**Staff Report**  
**City of Richmond, Virginia**

**Commission of Architectural Review**

6. COA-153782-2024	Final Review	Meeting Date: 9/24/2024
Applicant/Petitioner	John Cronly	
Project Description	Construct a third story rear addition.	
Project Location		
Address: 6 North Arthur Ashe Boulevard		
Historic District: Boulevard		
<p><b>High-Level Details:</b></p> <p>The applicant requests approval to construct a third story rear addition on a 2 ½ story detached row house built circa 1920. The house has a tiled, clipped gable roof with one hipped dormer window and a covered one-story porch with square columns. The main roof behind the front gable is flat.</p> <p>The addition will “bump-out” the rear of the front gable on the third story and the flat portion of the rear roof will be used as a rooftop deck enclosed with a simple railing.</p> <p>The addition will not be visible from Arthur Ashe Boulevard and will be minimally visible from the rear alley.</p>		
Staff Recommendation		
Staff Contact	Alex Dandridge, alex.dandridge@rva.gov, (804) 646-6569

Figure 6. Arial view of clipped gable and rear flat roof.

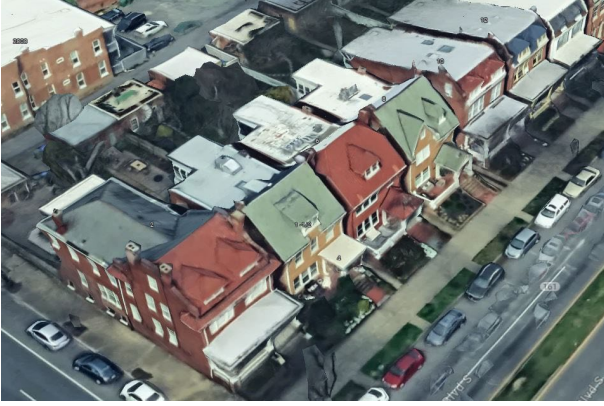
The addition will have windows and doors across the rear elevation. This will consist of a row of three casement windows flanked on either side by single pane glass doors. This is not a common fenestration pattern found within the district; however, these windows and doors will be minimally visible from the alley as the addition will be set far back from the alley and at a height that is not very visible.
